Subject: Acceptability of Comanche Peak Steam Electric Station
(Units 1 and 2) Conformance with TMI Action Plan Item
II.F.2, "Inadequate Core Cooling Detection System"

INPUT TO SSER FOR COMANCHE PEAK UNITS 1 AND 2

4.4.6.3 Instrumentation for Inadequate Core Cooling Detection

FIG. 1 CORE EXIT THERMOCOUPLE TRAIN A
DISPLAYS (TRAIN B SIMILAR)

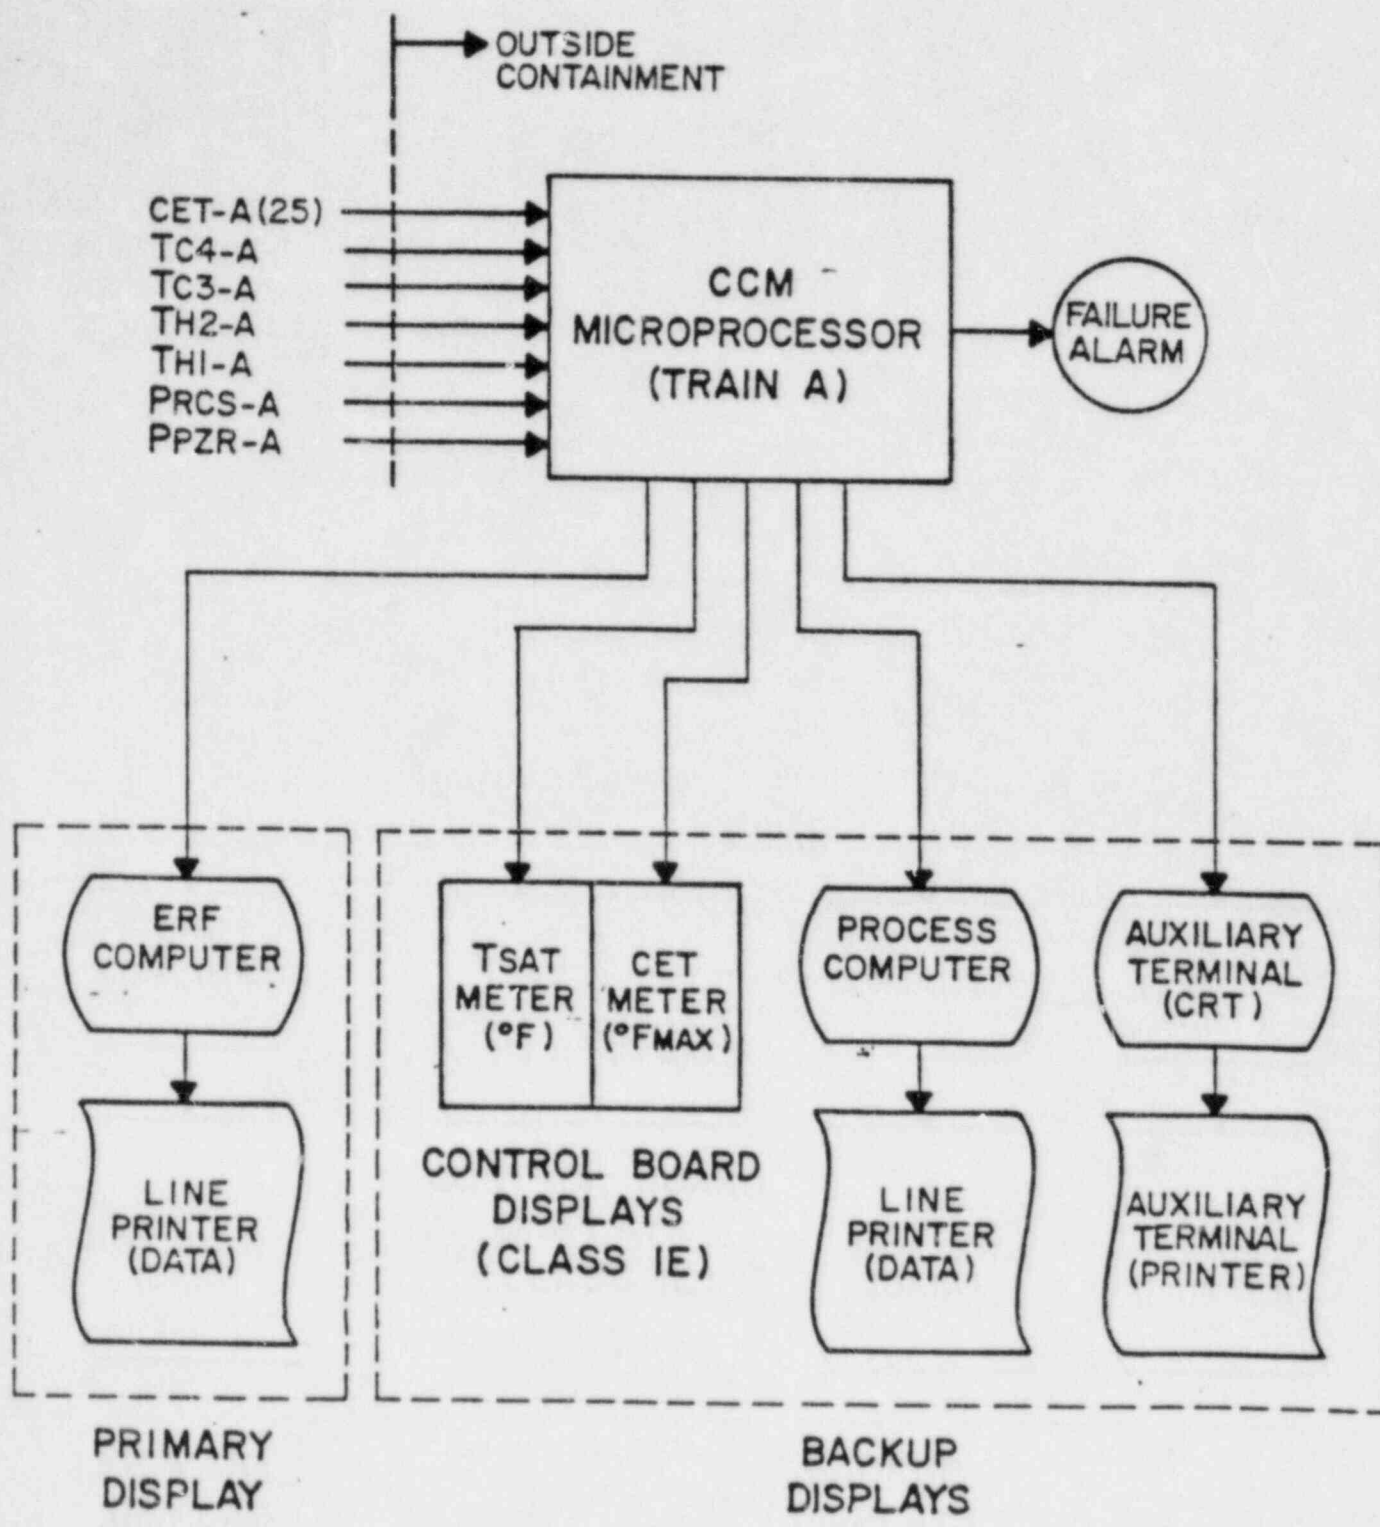
With one temporary exception, the ERF computer system meets all specific requirements of NUREG-0737 Item II.F.2, Attachment 1, for the primary display of CET measurements. Currently, the system software does not include provision of a spatially oriented core map of CET temperature readings. However, the design calls for this feature to be included prior to October 1985. Meanwhile, core-map capability is provided by a computer-based backup display discussed below.

Various other display channels are available to assure capability for monitoring ICC conditions based on CET measurements. The most reliable CCM displays are the redundant Control Board analog meters. These displays and associated hardware are fully-qualified, Class 1E.

The Control Board meter displays (which employ the highest valid CET temperature measurement) meet the specific back-up display requirements delineated in NUREG-0737, Attachment 1, except for the requirement for selective reading of a limited number of thermocouples from each core quadrant. However, multiple, additional CET-measurement displays which will provide redundant information from which selective readings can be obtained to determine changes in the radial distribution of the reactor coolant temperature are available. These additional display channels include continuous output from the Plant Process Computer (which provides core-map capability) and optional auxiliary output directly from the CCM via an instrument service port to which a standard computer terminal (moveable CRT and/or printer) can be connected. As in the case of the primary display, both of these available backup displays receive signal data from redundant, qualified CCM-output channels which are separated up to and including the isolation device. In both cases, displayed information available on demand includes an array of all CET measurements from which selective readings or the radial distribution of readings within each core quadrant can easily be obtained.

The Figure 1 illustrates the various displays available for use at CPSES to indicate plant status based on CET measurements.
